# **Statement of Response to An Bord Pleanála Opinion**

## **Proposed SHD Application**

**Lands at ‘St. Teresa’s’  
Temple Hill, Monkstown,  
Blackrock, Co. Dublin**

**On behalf of  
Oval Target Limited.**

### OMP Site Plan showing section lines

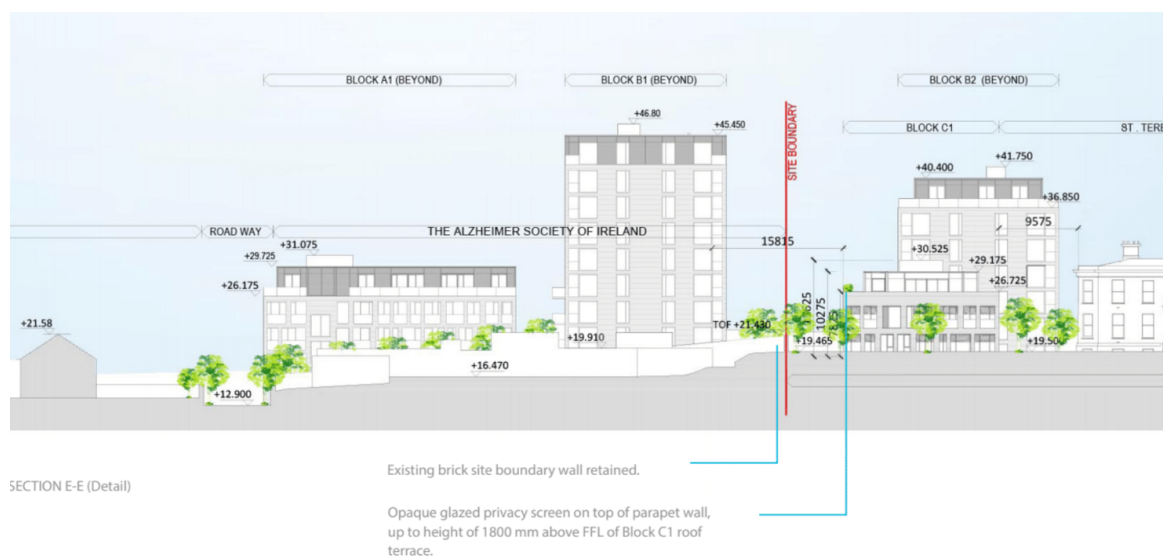
- (a) *The interface with The Alzheimer Society, interface with Temple Hill Road, interface with Rockfield Park and interface with St. Teresa's House as they relate to the design, scale and layout of the proposed development and the desire to ensure that the proposal provides a high quality, positive intervention at this location. This should include a contextual layout plan which indicates the layout of adjoining developments, photomontages and cross sections at appropriate levels.”*

For the convenience of the Board, we now provide a visual summary of the main interfaces as listed above. Firstly, the location of the detailed cross sections is shown as follows:

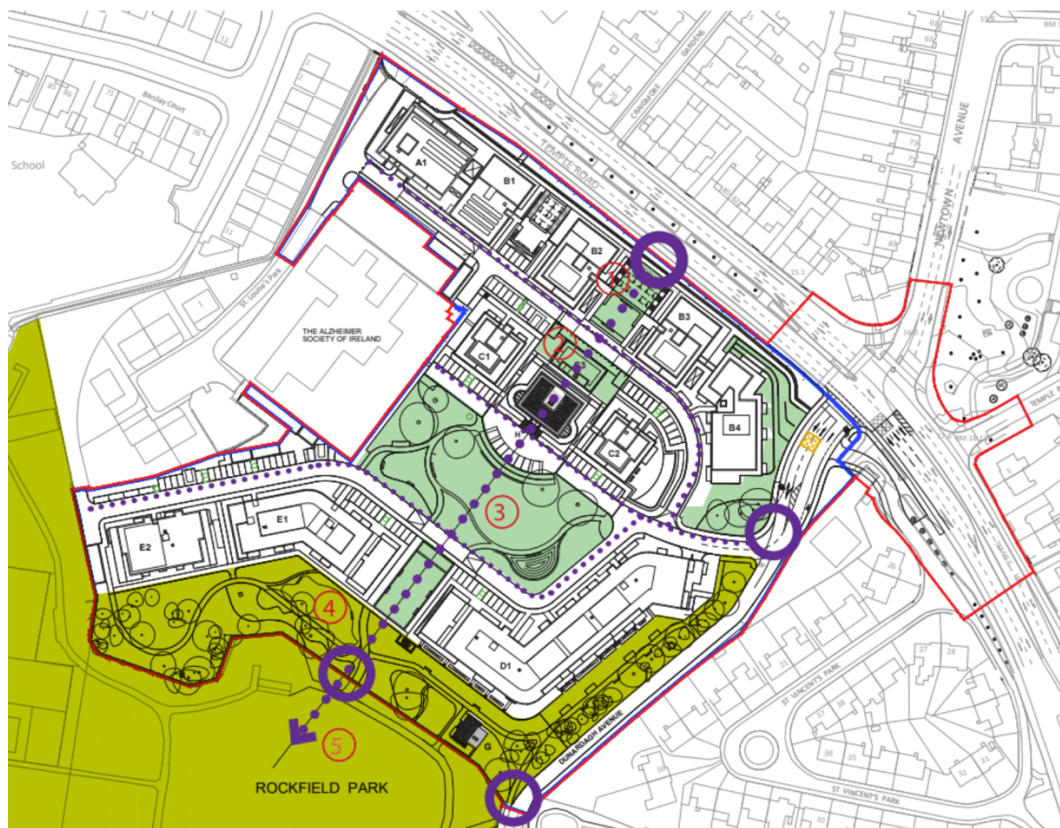
***(b) A response to the issues raised in the report of the Transportation Planning Section of Dun Laoghaire Rathdown County Council, as contained in the Planning Authority's Opinion received by An Bord Pleanála on 9<sup>th</sup> April 2021.***

The scheme provides 50no. Electric vehicle charging points dispersed through the development in accordance, with Development Plan requirements. The spaces are located as follows:

- Basement car park A , 12 no. charging points
- Basement car park B , 14 no. charging points
- Basement car park D , 14 no. charging points
- Surface level parking , 10 no. charging points
